SUBJECT: TECHNICAL REVIEW: SALTSTONE WASTE FORM PHYSICAL  
DEGRADATION (DOCKET NO. PROJ0734)

## **Technical Review: Saltstone Waste Form Physical Degradation**

The purpose of this NRC staff Technical Review Report (TRR) is to describe recent research results related to saltstone degradation, evaluate the U.S. Department of Energy (DOE) revised assumptions about saltstone degradation that is in both the DOE Fiscal Year (FY) 2013 and DOE FY 2014 Saltstone Disposal Facility (SDF) Special Analysis Documents<sup>1</sup>, and describe the potential effects of degradation on Savannah River Site (SRS) SDF performance. Release of iodine and technetium (Tc) are discussed in more detail in radionuclide-specific TRRs (ADAMS Accession Nos. ML16342C575 and ML18095A122, respectively).

Figure 16: PORFLOW Near-Field Model Cumulative Volumetric Flow through Several Materials in SDS 4 (Prepared from DOE PORFLOW Data)

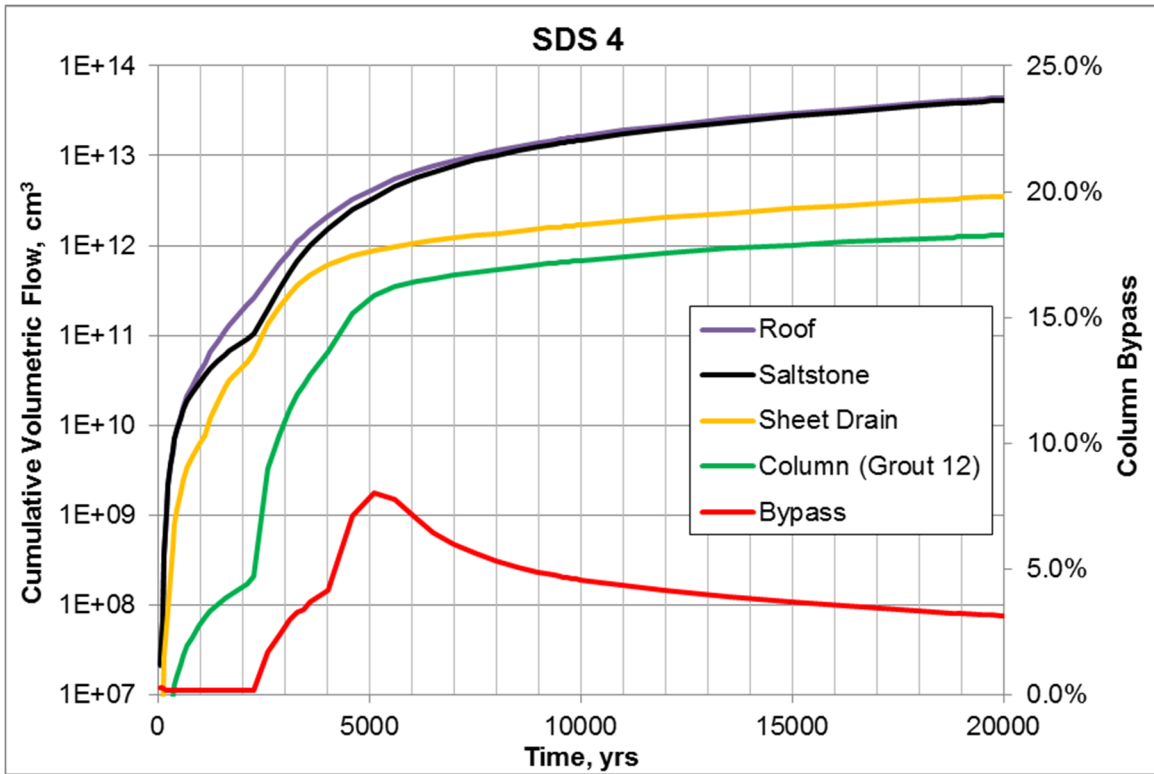
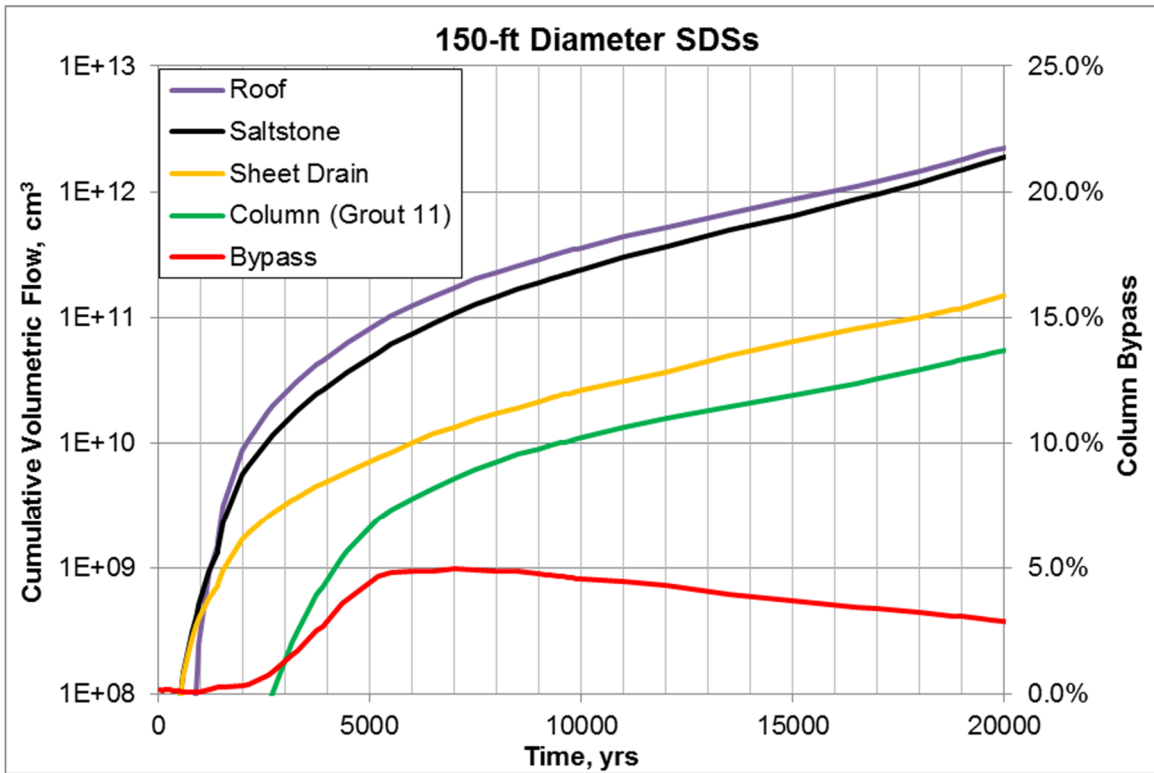
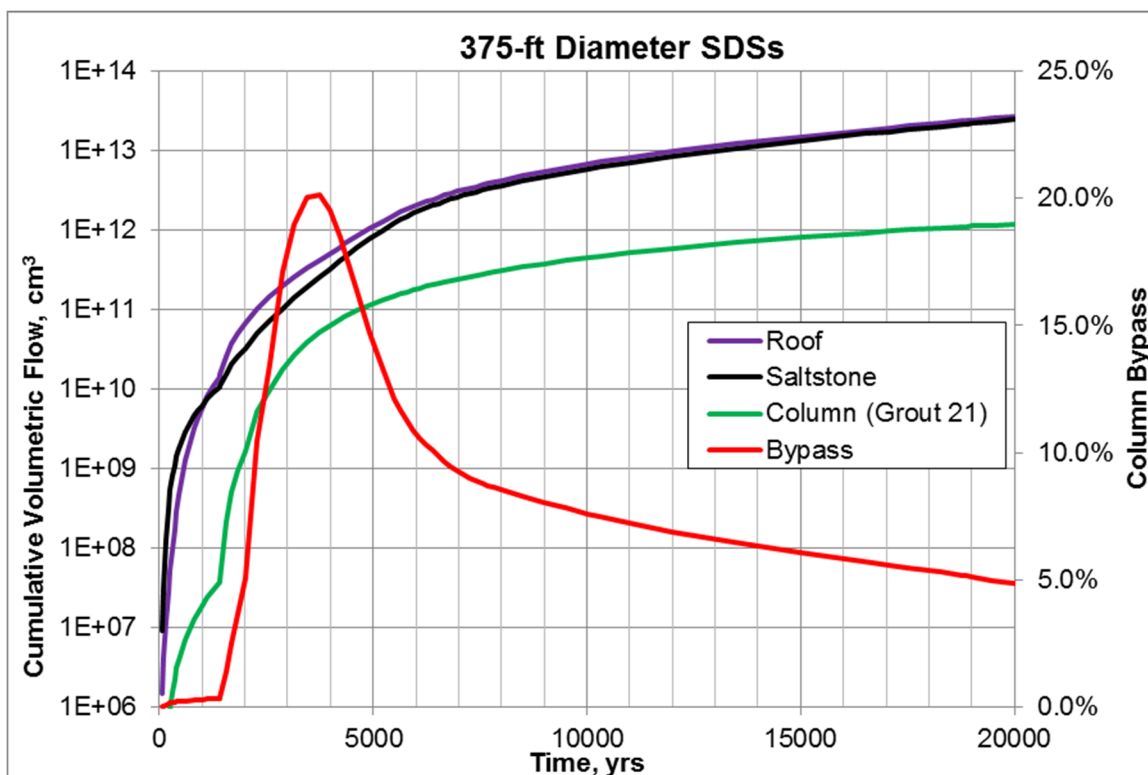
The cumulative volumetric flow through several saltstone materials<sup>12</sup> in SDS 4, the 46-m (150-ft) and 114-m (375-ft) diameter disposal structures in Figure 16, Figure 17, and Figure 18 shows that the assumed degradation in the FY 2014 SA results in a portion of the infiltrating water bypassing the saltstone grout. Those figures show that bypass flow through the columns in SDS 4 and the 46-m (150-ft) and 114-m (375-ft) diameter disposal structures is limited and does not exceed 25% of the flow through the saltstone grout and is typically less than 10%. The NRC staff acknowledges that there is uncertainty in the degradation analysis; but, the DOE predicts the effect of bypass flow to be limited and the NRC staff agrees with the DOE. Other assumptions (e.g., saltstone degradation, Tc solubility, I sorption) in the FY 2013 and FY 2014 SAs are much more risk significant. However, if the DOE assumes in future analyses that more water will bypass the saltstone grout, then additional support may be necessary.
